HISTORIC AND DESIGN REVIEW COMMISSION

May 18, 2022

HDRC CASE NO: 2022-200
ADDRESS: 323 REFUGIO ST
LEGAL DESCRIPTION: NCB 714 BLK 11 LOT S IRR 63.8 FT OF 14 AT 323 REFUGIO
ZONING: RM-4, H
CITY COUNCIL DIST.: 1
DISTRICT: Lavaca Historic District
APPLICANT: Marcello Martinez/1718 Archtitecture
OWNER: Kevin Allison/ALOHA HOME SOLUTIONS INC
TYPE OF WORK: Construction of a rear addition, rehabilitation, construction of a new front porch
APPLICATION RECEIVED: March 31, 2022
60-DAY REVIEW: Not applicable due to City Council Emergency Orders
CASE MANAGER: Claudia Espinosa

The applicant is requesting a Certificate of Appropriateness for approval to:

New Elevation

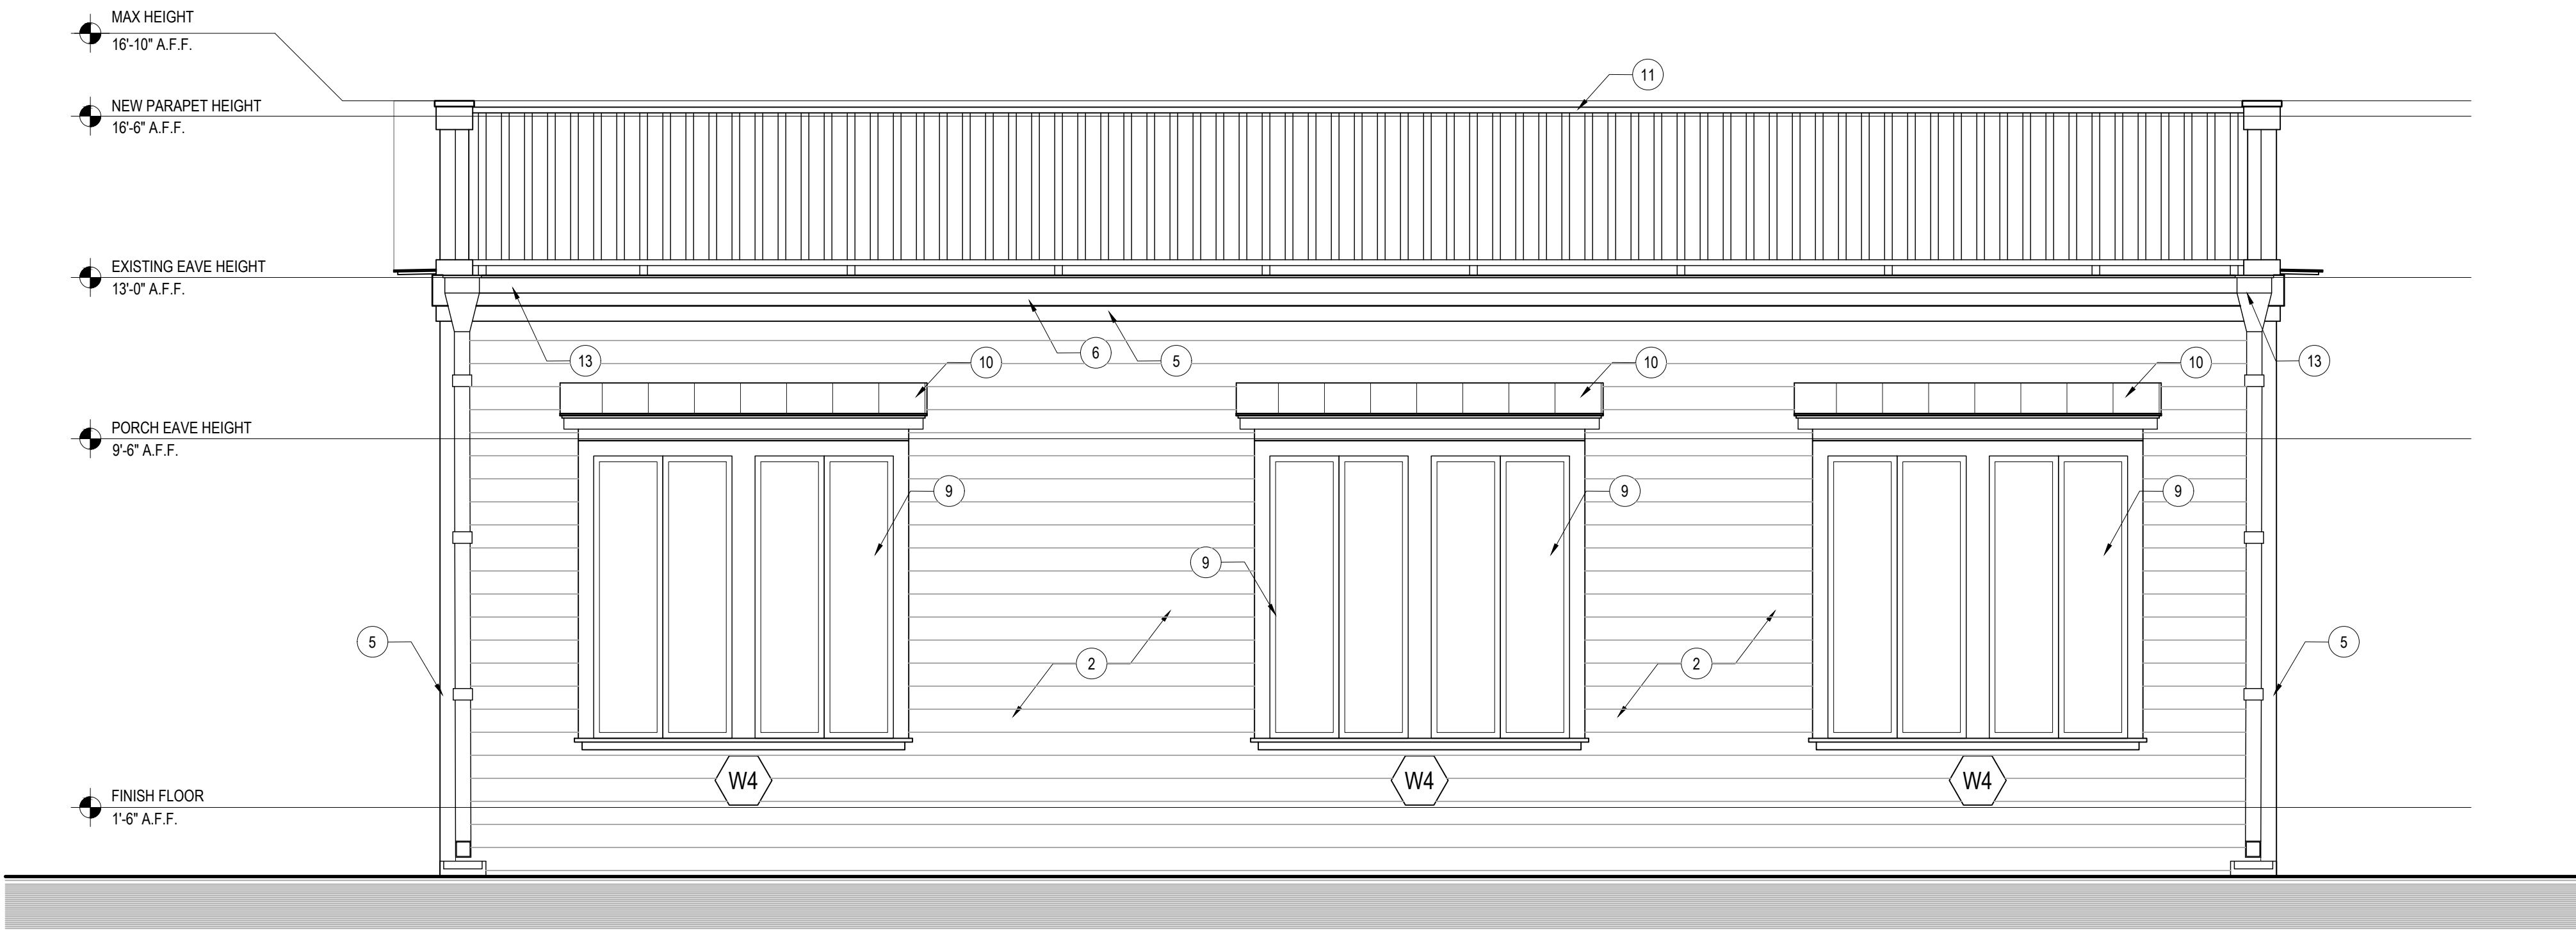
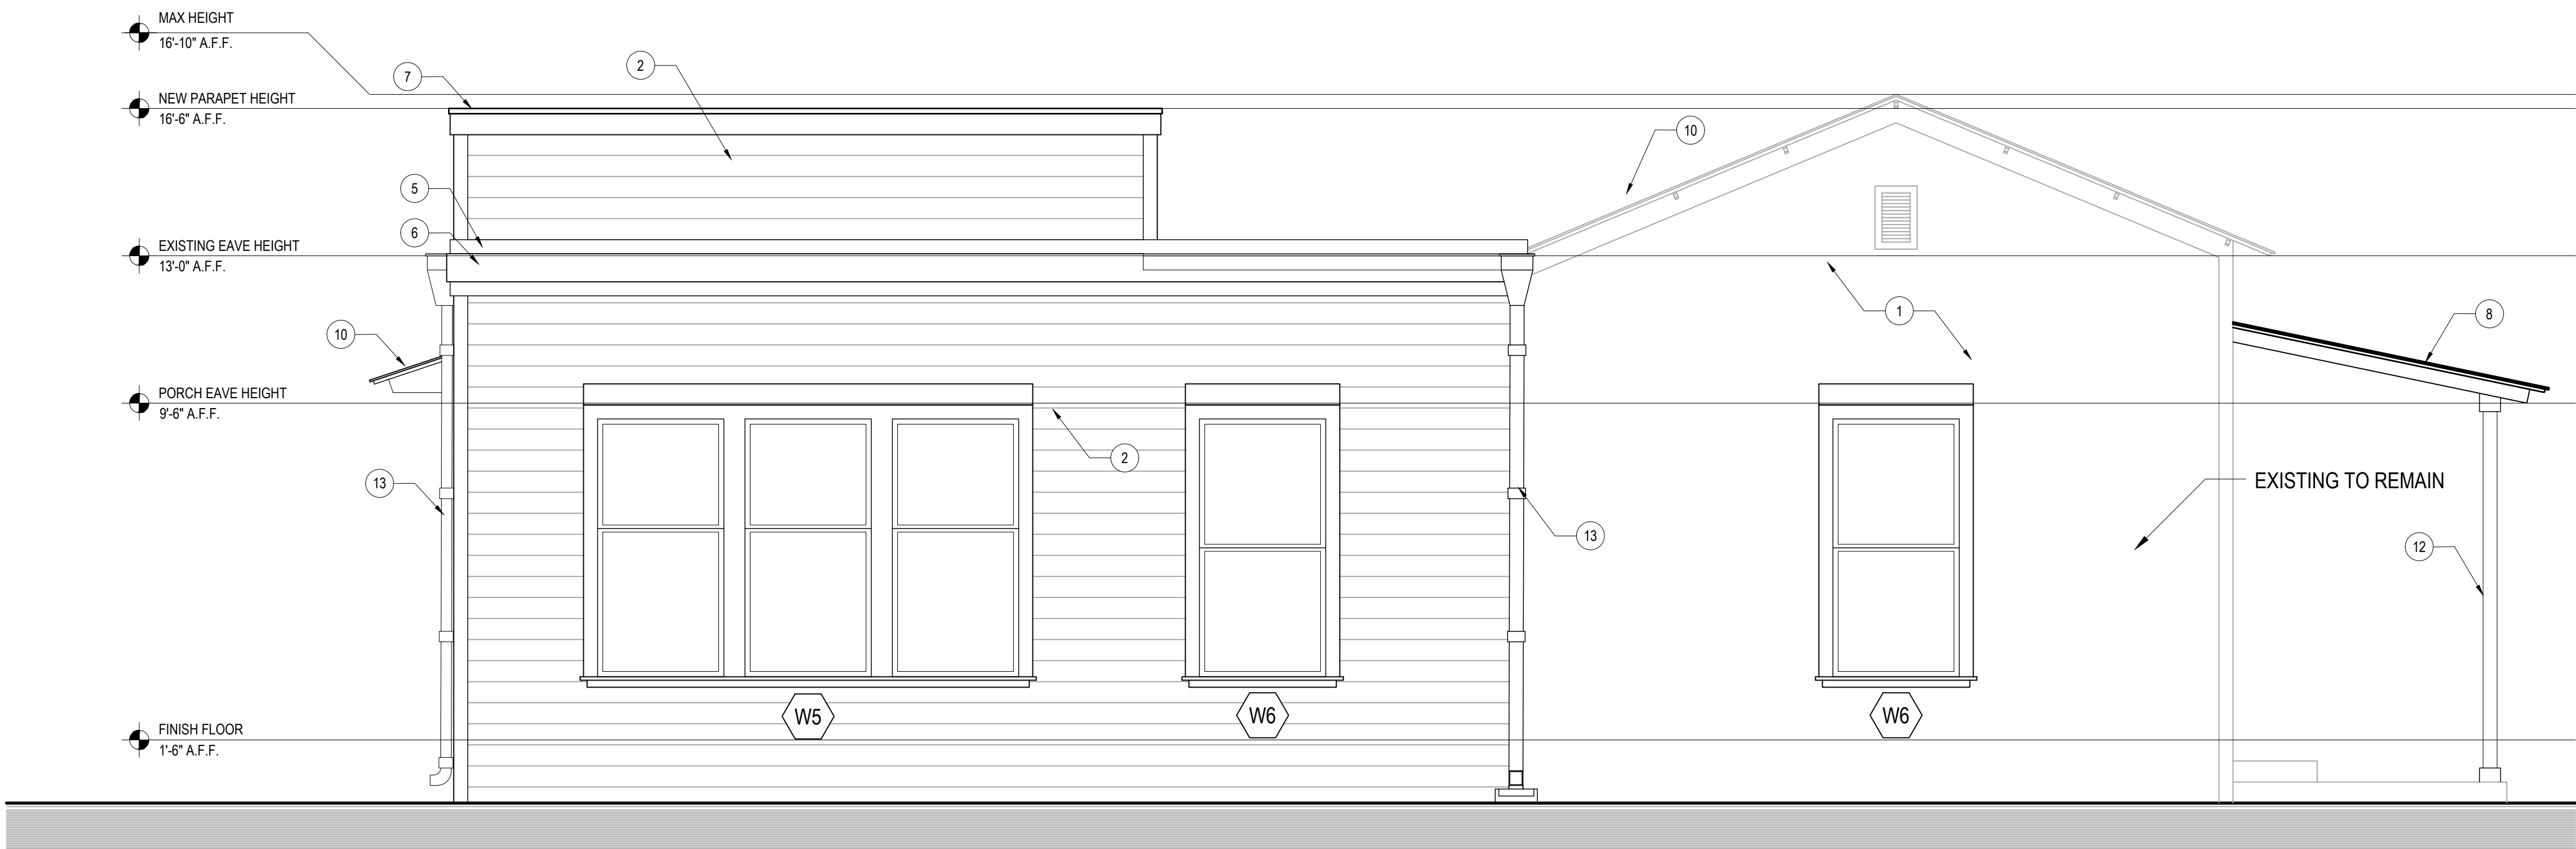
- g. **ADDITION: ROOF** – The applicant has proposed to install a flat roof form with a parapet on the addition. The addition will modify the roof form of the primary structure and will result in the removal of the character defining rear slope into a shed roof. The roof form of the addition will be highly visible from the public right-

of-way. Guideline 1.A.iii for Additions stipulates that residential additions should utilize a similar roof pitch, form, overhang, and orientation as the historic structure. Staff finds that the flat roof form might be appropriate for the structure if it was not visible from the public right-of-way and if the addition did not modify the existing roof form. Staff finds that the applicant should propose a roof form that is similar to the historic structure or appropriate for the style and that the applicant should avoid modifying the original roof form.

- j. **ADDITION: NEW WINDOWS AND DOORS: SIZE AND PROPORTION** – The applicant has proposed to install windows with traditional proportions on the north, east, and west elevations and a small window on the south (front) elevation of the addition. The applicant has proposed to install one (1) full-lite wood door on the east elevation and one (1) set of full-lite wood French doors on the north (rear) and west elevations. Staff's standard window specifications state that new windows should feature traditional dimensions and proportions as found within the district. Staff finds that the applicant should modify the proposal to feature windows of traditional proportions on the south (front) elevation.

- i. That the applicant reduces the overall massing of the rear addition and proposes a rear addition that is inset from the existing wall planes on finding f.
- ii. That the applicant proposes a roof form that is similar to the historic structure or appropriate for the style and does not modify the existing roof form based on finding g.
- iii. That the applicant updates the proposal to feature windows of traditional proportions on the south (front) elevation based on finding j.
